RUN-ON AND RUN-OFF CONTROL SYSTEM PLAN

Iatan CCR Landfill

Appendix A – Stormwater Design Calculations Review

Review of Iatan CCR Landfill Storm Water Plan Calculations EVERGY, 2021

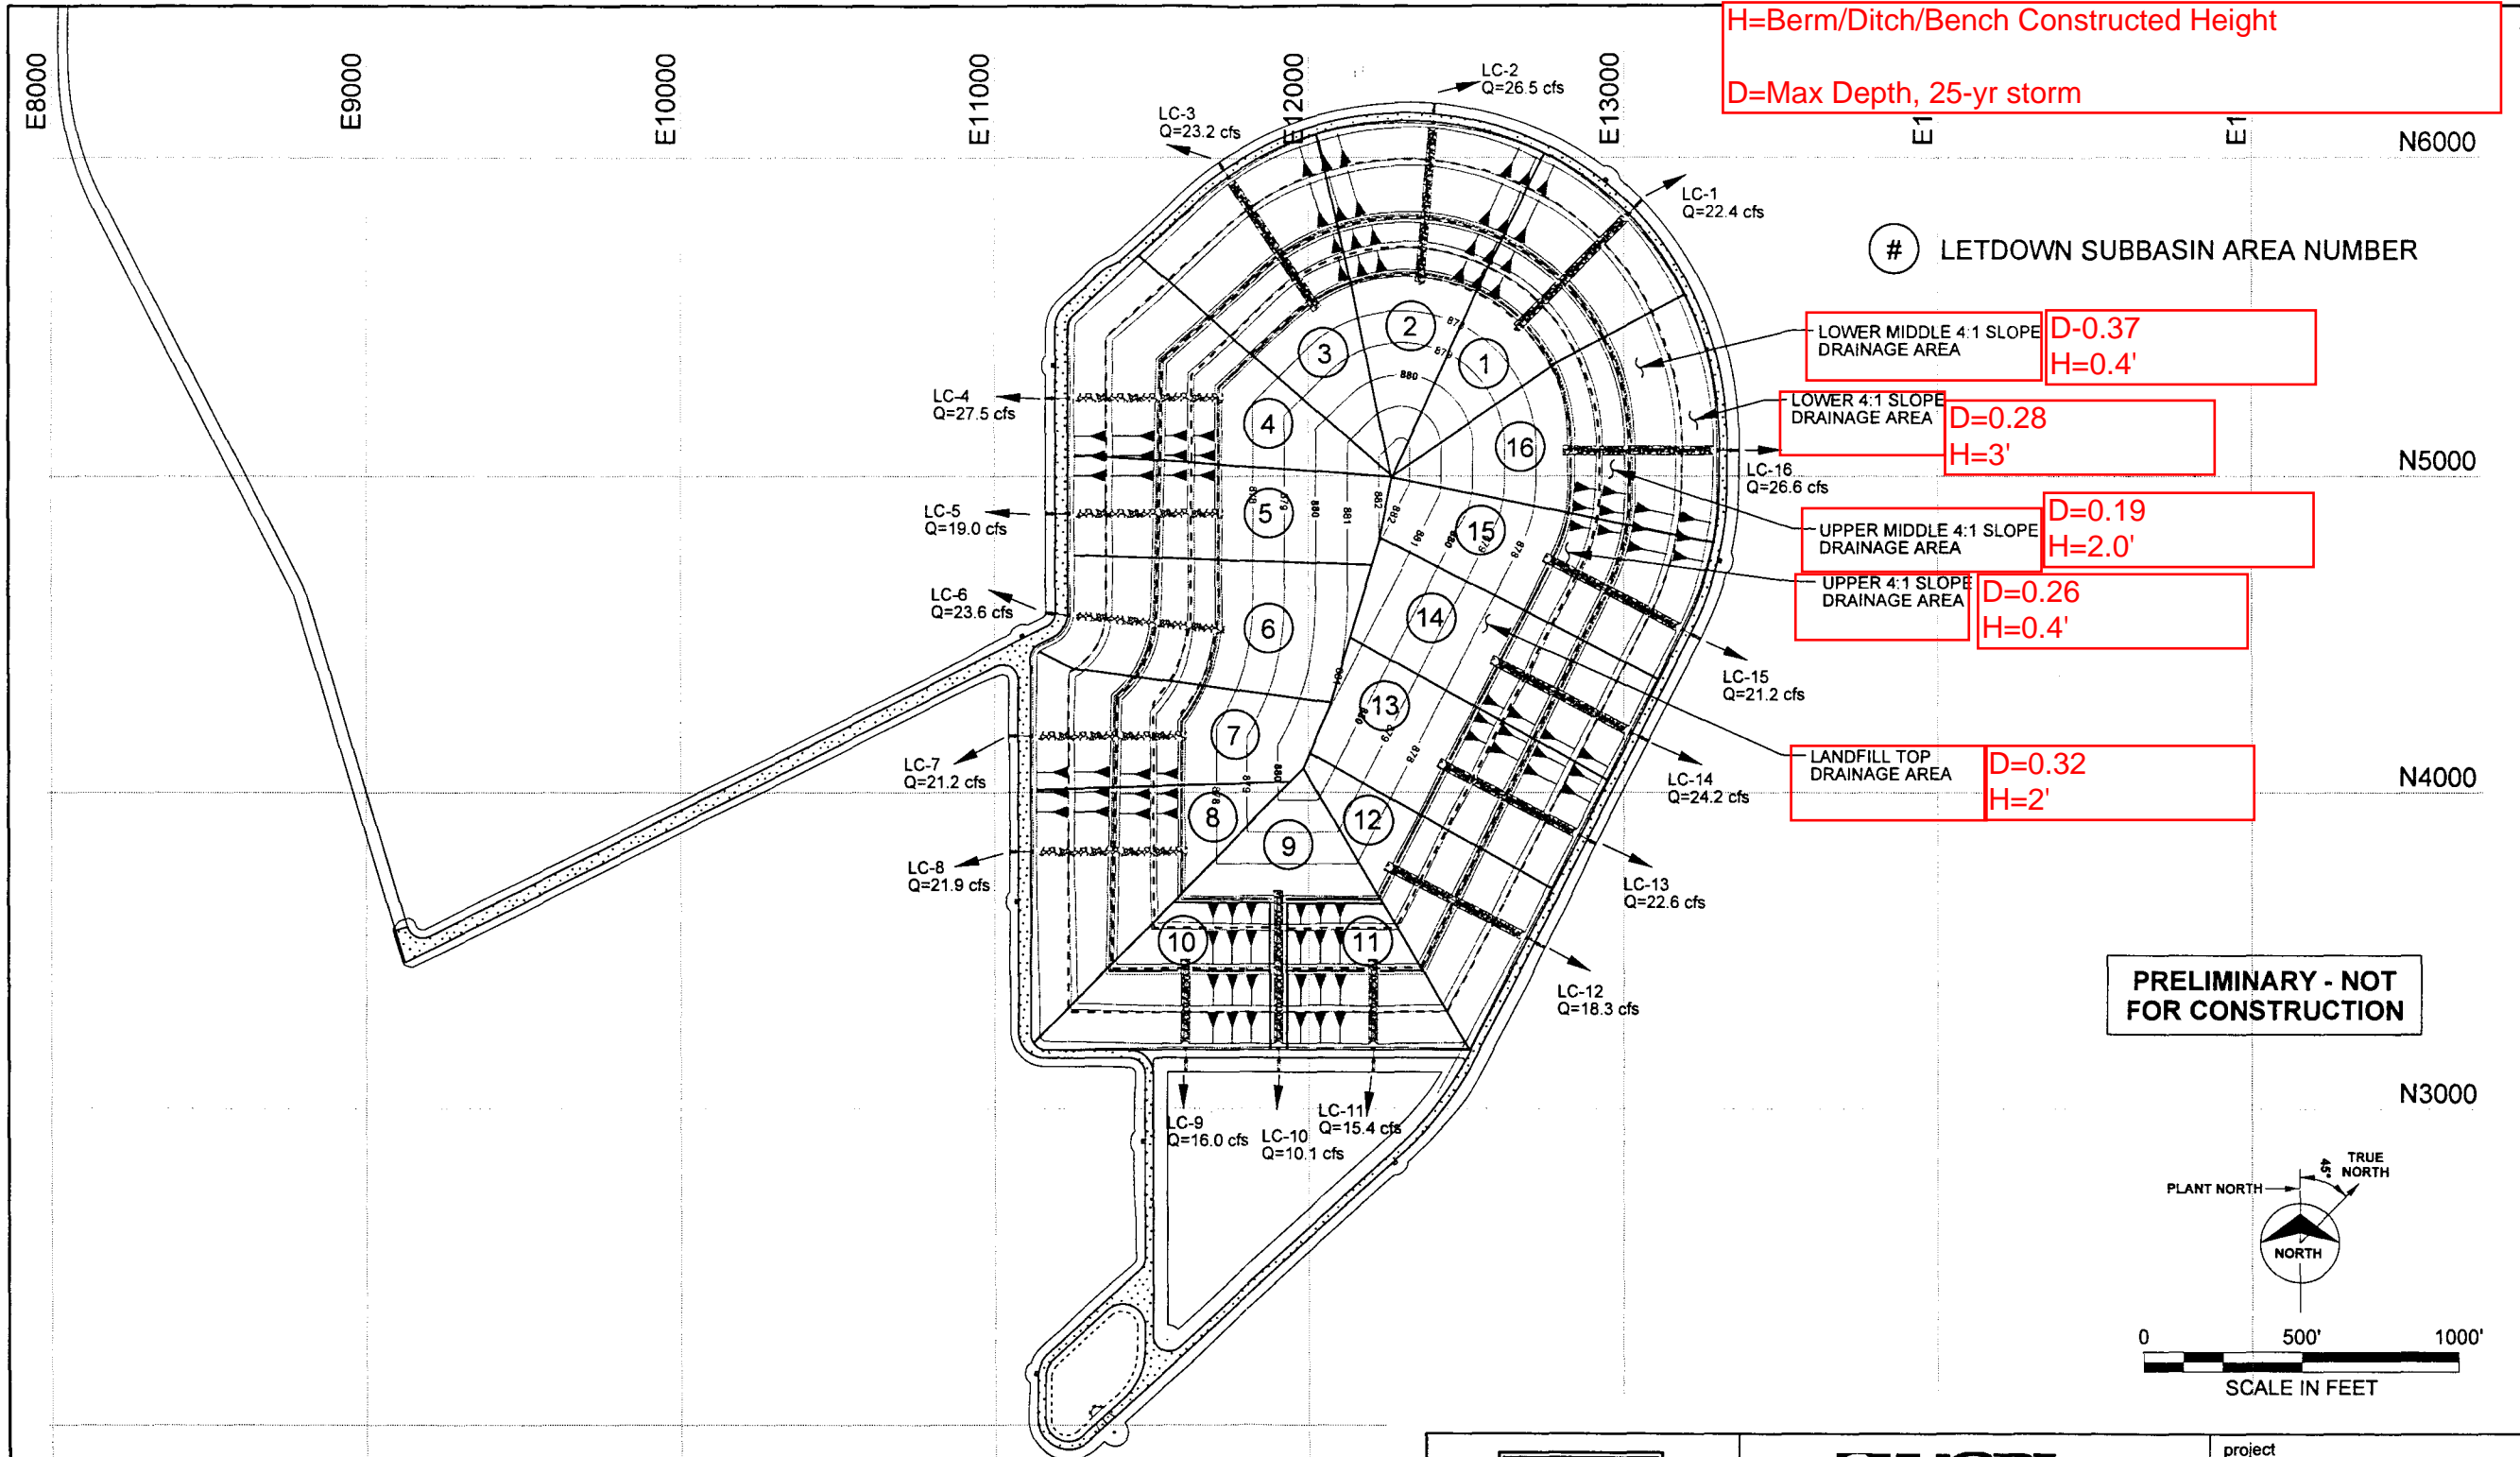
discussions above said these was the max for those sections. Not an issue since 4.2 (8.4 total) is the max flow and design basis (0.37' depth).

see flow for Lower Middle outflow
